# Access Compliance Report

## Public Rights-of-Way

### (Curb Ramps)

Intersection ID: 19935	Main Street: MORRISON_BV	Cross Street: ADAIR_CT	Location: NE
ADA ID: A1F19048AE3B	Ramp Type: ParaDiag	Initial Pass/Fail: Fail	Overall Compliance: No
Codes/Mitigation Info/Possible Solution			Severity Score: 50
			Field Measurements/Component Compliance

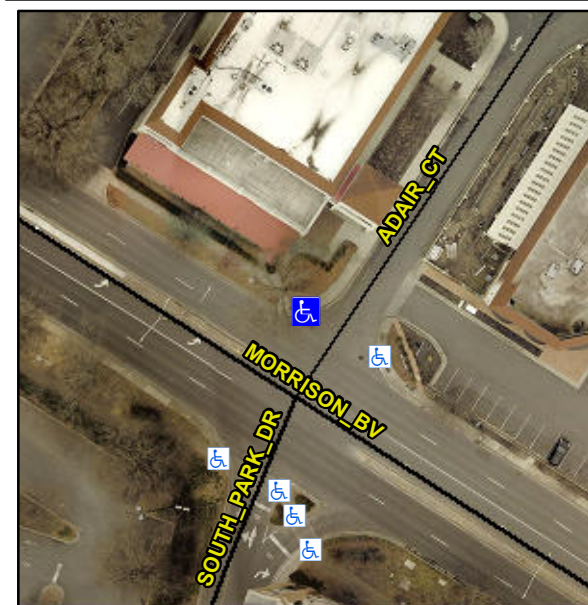
**LT RP < 5%**

**R304.5.3, R304.3.2**

Compliance	Description	Data	Compliance	Description	Data
N/A	Ramp Length LT (in)	64.0	N/A	Ramp Length RT (in)	51.0
Yes	Ramp Width LT (in)	54.0	Yes	Ramp Width RT (in)	67.0
Yes	Ramp Slope LT (%)	4.9	No	Ramp Slope RT (%)	16.1
No	Ramp XSlope LT (%)	14.9	No	Ramp XSlope RT (%)	7.3
N/A	Landing Length (in)	N/A	N/A	DWS Provided?	N/A
N/A	Landing Width (in)	N/A	N/A	DWS Contrast?	N/A
N/A	Landing Slope (%)	N/A	N/A	DWS Length (in)	N/A
N/A	Landing X Slope (%)	N/A	N/A	DWS Full Width?	N/A
N/A	Landing Curb? (Y/N)	N/A	N/A	DWS Offset (in)	N/A
N/A	Shared Landing?	N/A			
N/A	Gutter Ponding?	N/A	N/A	Gutter Slope (%)	N/A
N/A	Gutter Lip Ht (in)	N/A	N/A	Gutter X Slope (%)	N/A
N/A	Painted X Walk1?	No	N/A	Painted X Walk2?	No
	X Walk 1 Direction	To SW		X Walk 2 Direction	To SE
N/A	X Walk 1 Width (in)	N/A	N/A	X Walk 2 Width (in)	N/A
	X Walk 1 Slope (%)	0.9		X Walk 2 Slope (%)	0.9
	X Walk 1 X Slope (%)	3.7		X Walk 2 X Slope (%)	1.9
N/A	Ramp inside XWalk1?	N/A	N/A	Ramp inside XWalk2?	N/A

**Remove & Replace Curb Ramp With Two New Directional Ramps or Equivalent.**
